## SINGAPOREAN NOTICES TO MARINERS

The monthly Notices to Mariners contain information required to keep charts and publications published by the Hydrographic Department, Maritime and Port Authority of Singapore up-to-date.

CORRECTION NO.	SNM EDN NO.	LAST CORRNO NO.	CHART NO.	Location on Chart		
<b>102 (Sheet 1)</b>	<b>11/2017</b>	<b>99/2017</b>	<b>501</b>			<b>X</b>

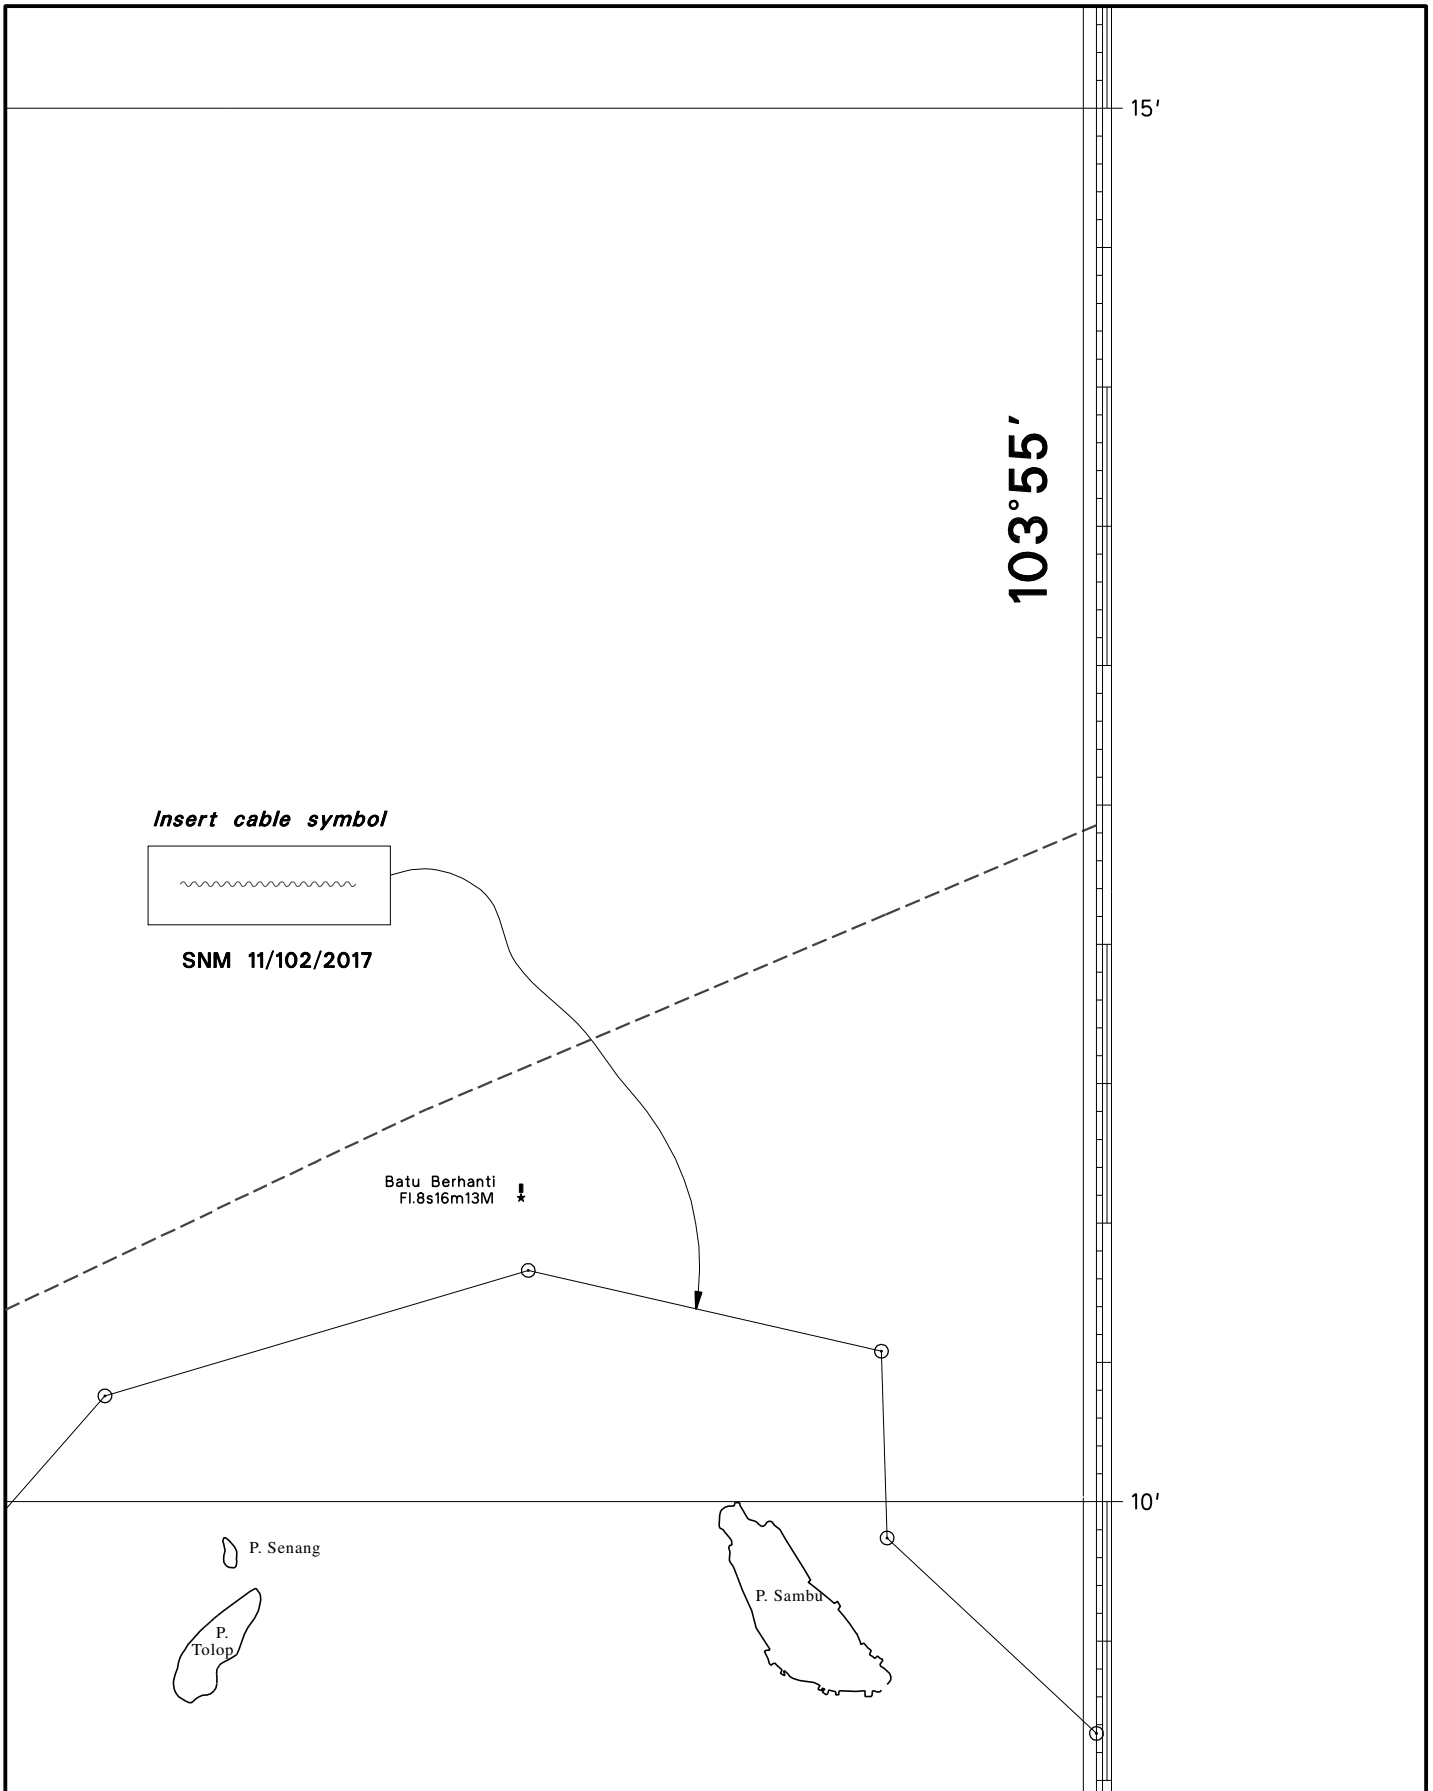
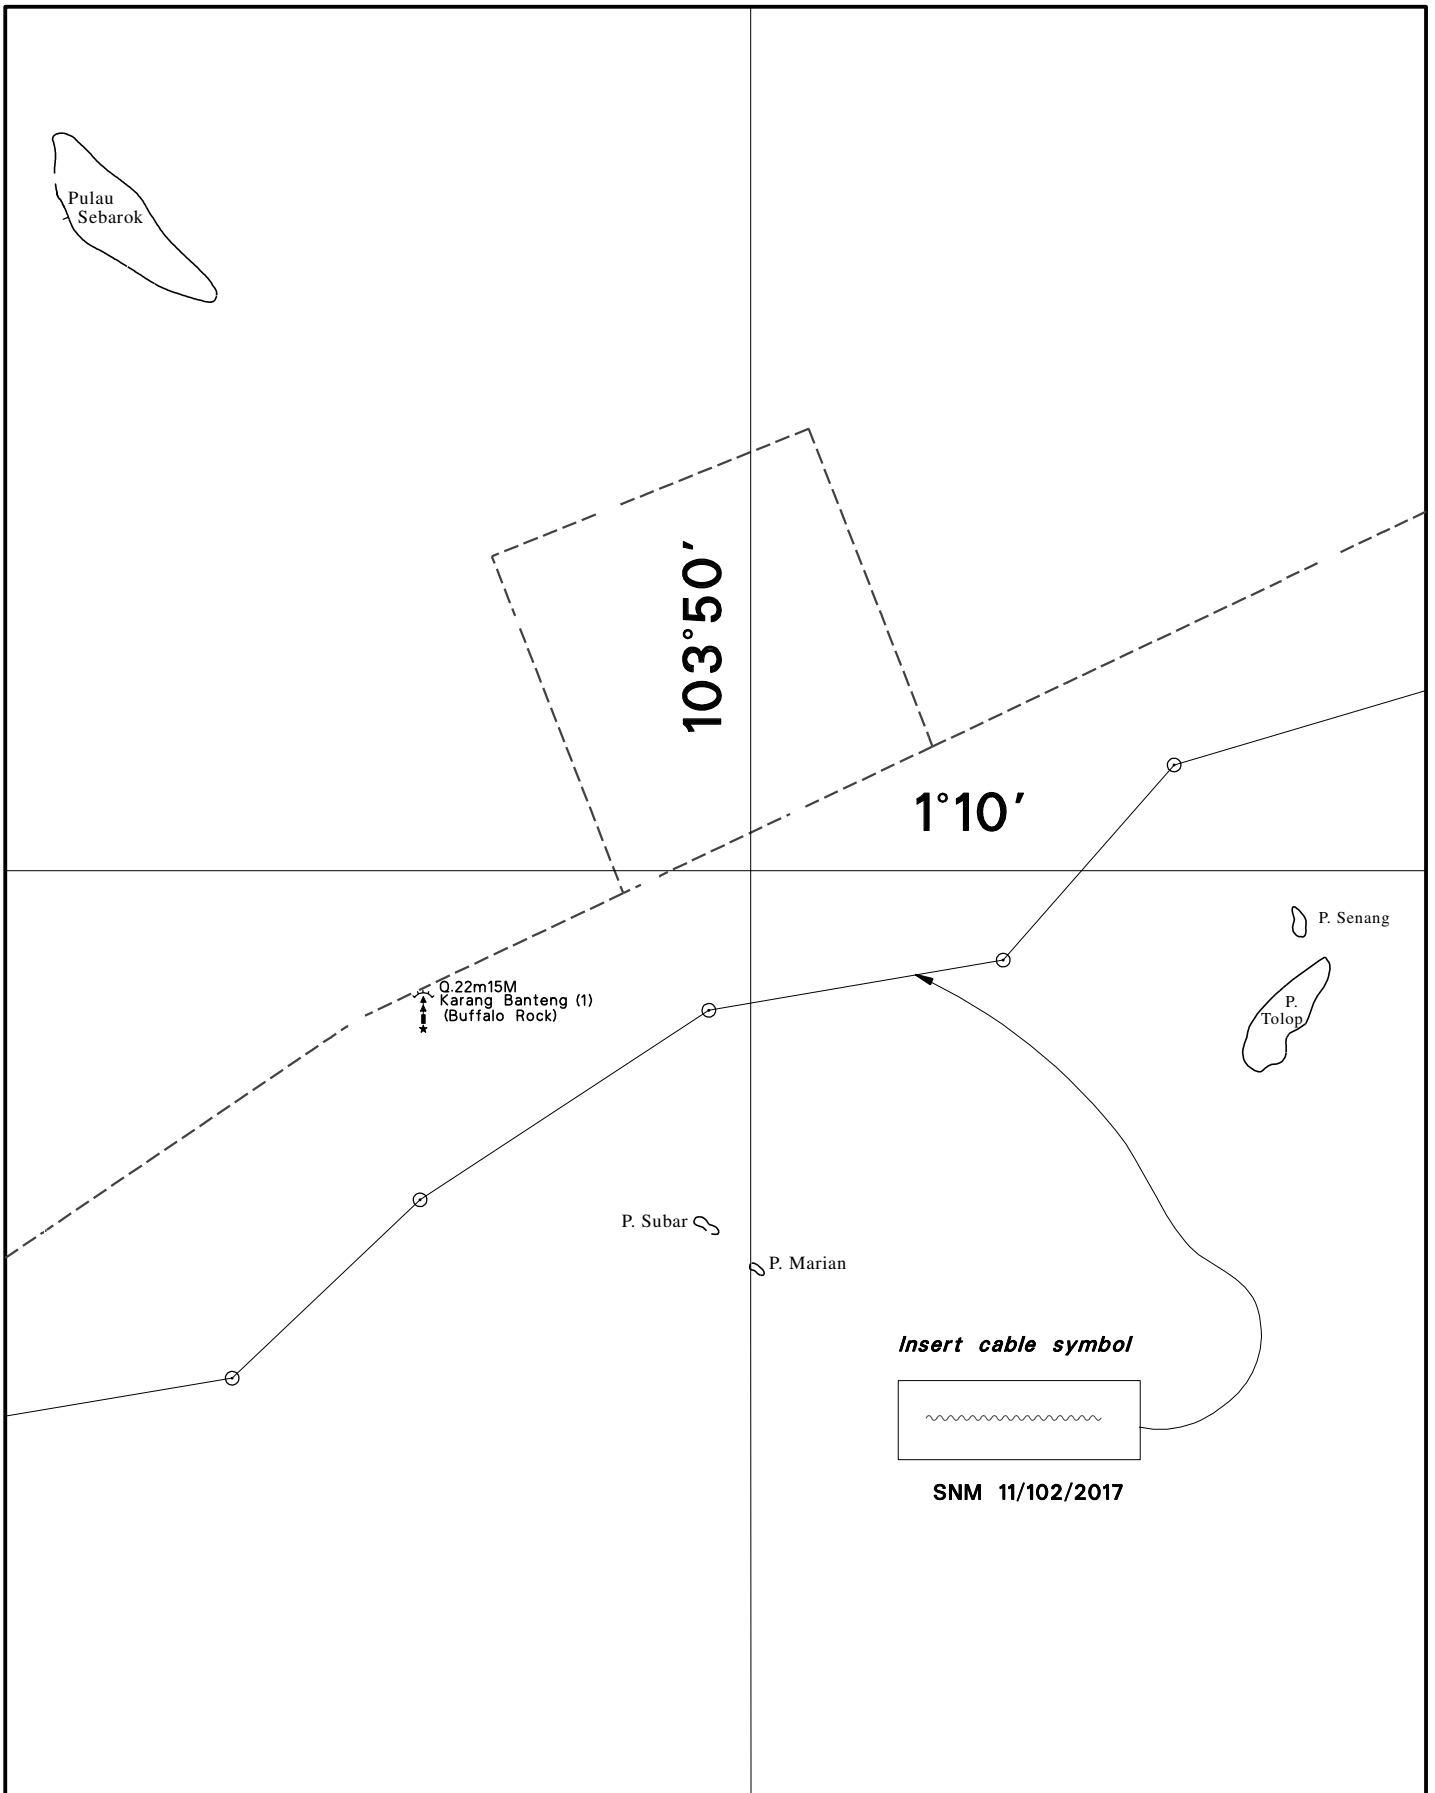
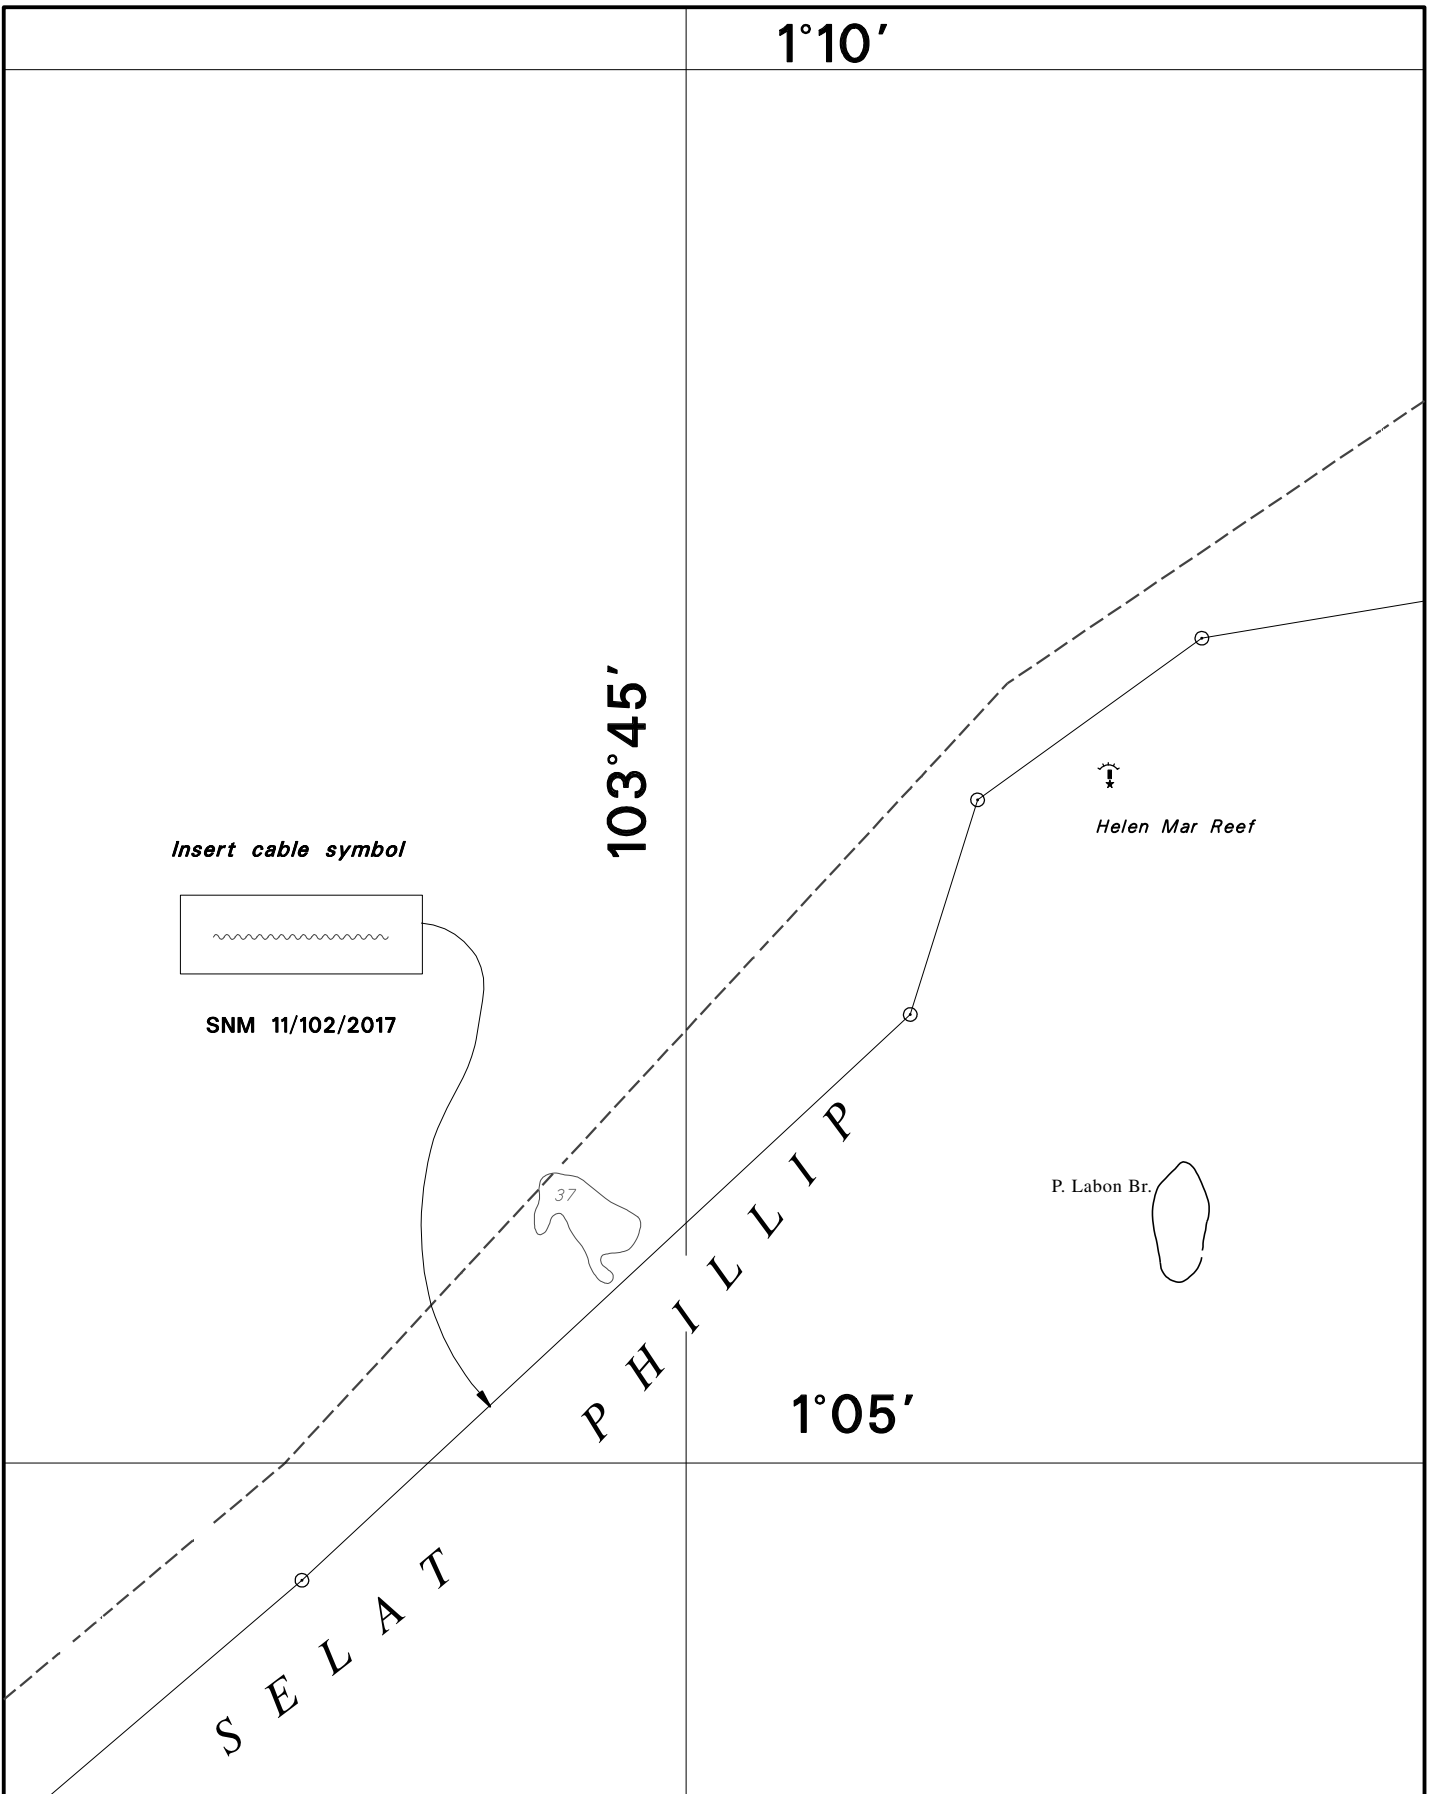
<b>502</b>	7 Ed 1/09/15 Last NM 88/2017	(Indonesian Notice No. 36/552/17)	<b>NM 102/2017</b>
<b>Insert</b>	submarine cable,  , joining :		
		1°08·59'N	103°55·31'E
		(shore)	
		1°08·95'N	103°55·28'E
		1°09·87'N	103°54·30'E
		1°10·54'N	103°54·28'E
		1°10·83'N	103°53·02'E
		1°10·38'N	103°51·51'E
		1°10·21'N	103°51·43'E
		(chart border)	
-----			
<b>503</b>	5 Ed 15/08/14 Last NM 94/2017	(Maritime and Port Authority of Singapore)	<b>NM 103/2017</b>
<b>Insert</b>	Automatic Identification System, <b>AIS</b> , on lighthouse		
		1°19·81'N	104°24·34'E
-----
